## **ALERT SERVICE BULLETIN**

**206L-24-189**

**MODEL AFFECTED:** 206L, 206L-1, 206L-3 and 206L-4

**SUBJECT:** TAIL ROTOR SEGMENTED DRIVESHAFT ASSEMBLY, ONE-TIME INSPECTION OF

**Figure 1 – Tail Rotor Drive System**

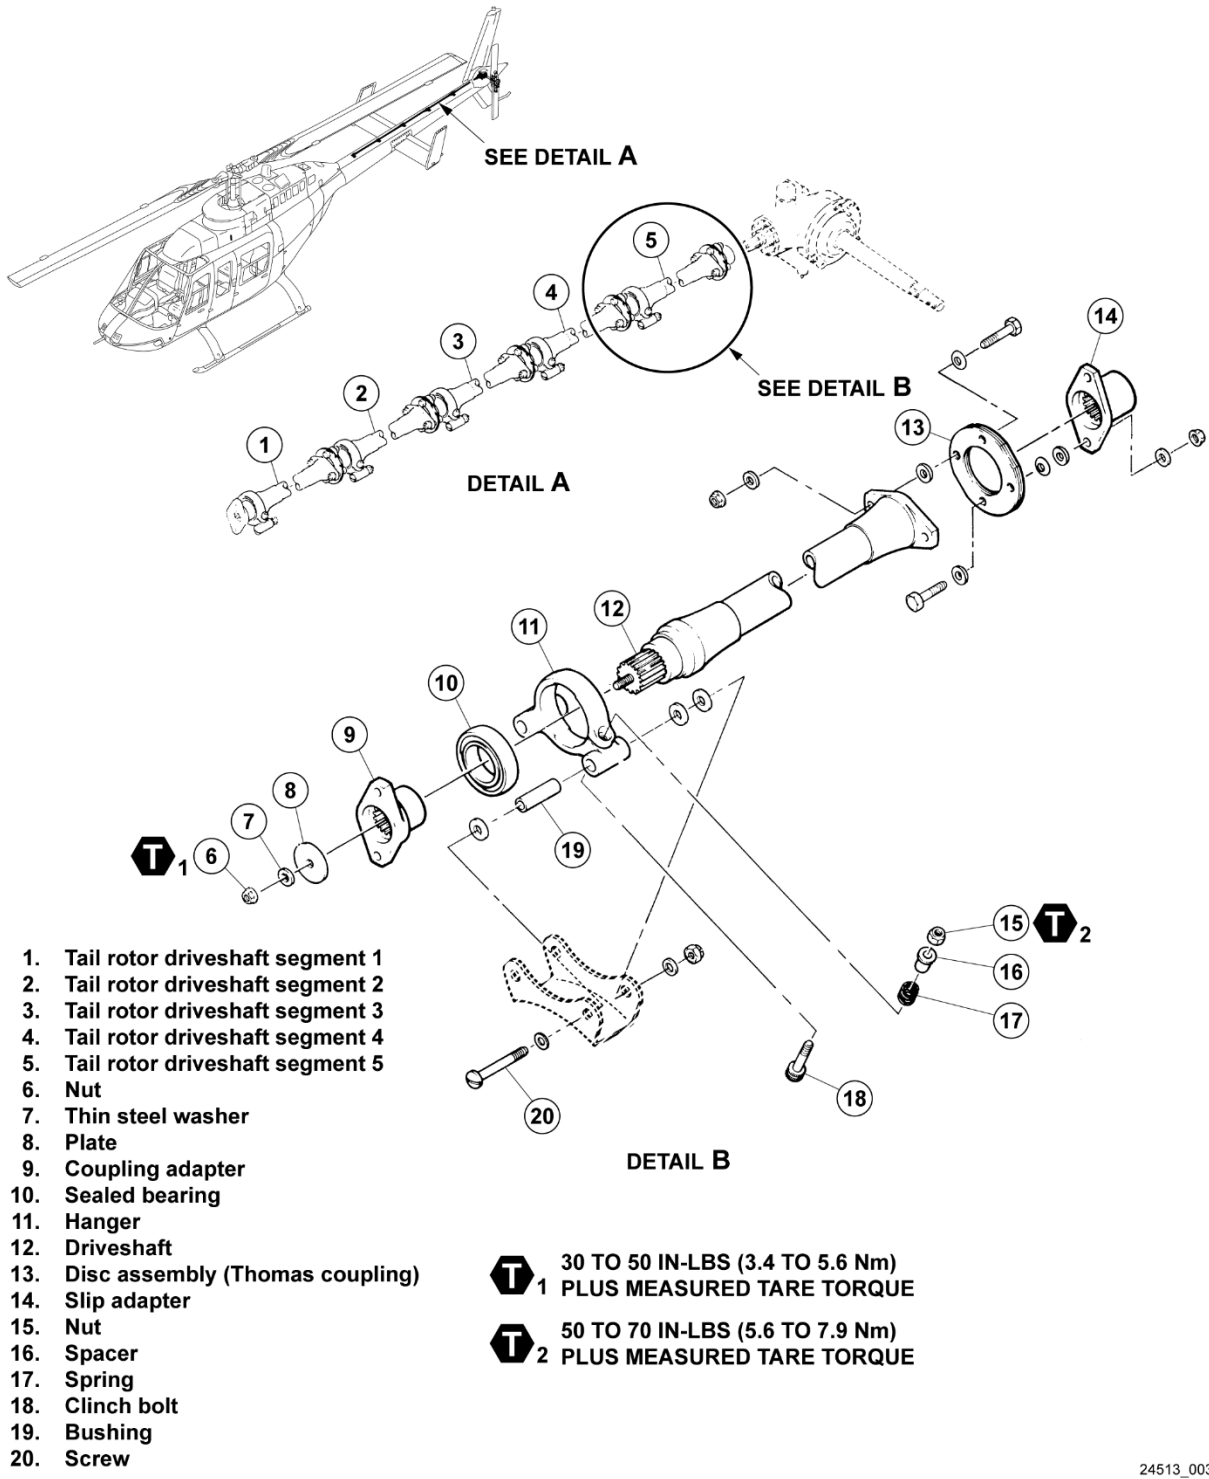
3. Inspect the tail rotor segmented driveshaft assembly splined adapters (9, Figure 1) for any noticeable axial (fore and aft) and radial play between the splined adapter (9) and the driveshaft (12) at all five locations (Figure 1).

- a. If there is no radial or axial play noted, do the following:
    - (1) Remove the aft short shaft directly aft of the fan shaft and the segmented shaft assemblies (2) and (4). Support the aft end of the segmented shaft (1) and (3) (applicable Maintenance Manual, Chapter 65).

- (2) Remove any torque seal lacquer (C-249) that may be applied to nut (6) on all five of the tail rotor segmented driveshaft assemblies.
    - (3) Unseat the nut (6) by loosening the nut by  $\frac{1}{2}$  to 1 turn at each tail rotor segmented driveshaft assemblies.

- (4) Measure the tare torque of the nut (6) using a dial indicator torque wrench.
      - (a) If the tare torque of the nut meets the minimum 3.5 inch-pounds (0.4 Nm), go to step (3.a.(5)).

- (b) If the tare torque of the nut is less than 3.5 (0.4 Nm), replace the nut with a serviceable nut and proceed to step (3.a.(4)(a)).
    - (5) Torque the nut (6) 30 to 50 inch-pounds (3.4 to 5.6 Nm) and add the measured tare torque in steps (3.a.(4)) to the specified torque.

- (6) Apply torque seal lacquer (C-249) across the threads of the stud of the driveshaft (12), the nut (6) and the plate (8). Go to step (4).
  - b. If radial or axial play is noted, perform the following:

- (1) Remove the aft short shaft directly aft of the fan shaft and the segmented shaft assemblies (2) and (4). Support the aft end of the segmented shaft (1) and (3) (applicable Maintenance Manual, Chapter 65).

- (2) Disassemble the applicable tail rotor driveshaft segment assembly (BHT-206L-CR&O).

- (a) Inspect the splined adapter (9) and splines of the driveshaft (12). Replace or repair parts if required (BHT-206L-CR&O).
- (3) Assemble the applicable tail rotor driveshaft assembly with serviceable parts (BHT-206L-CR&O).

- (a) Measure the tare torque of the nut (6) using a dial indicator torque wrench.
    - 1. If the tare torque of the nut meets the minimum value of 3.5 inch-pounds (0.4 Nm), go to step 3.b.(3)(b).

- 2. If the tare torque of the nut is less than 3.5 inch-pounds (0.4Nm), replace the nut with a serviceable nut and repeat step (3.a(4)).
  - (b) Torque the nut (6) 30 to 50 inch-pounds (3.4 to 5.6 Nm) and add the tare torque measured in step 3.a(4) to the specified torque.

- (c) Apply torque seal lacquer (C-049) across the threads of the driveshaft stud (12), the nut (6) and the plate (8).
- 4. Install the tail rotor segmented driveshaft assemblies 2 and 4 (applicable Maintenance Manual, Chapter 65).
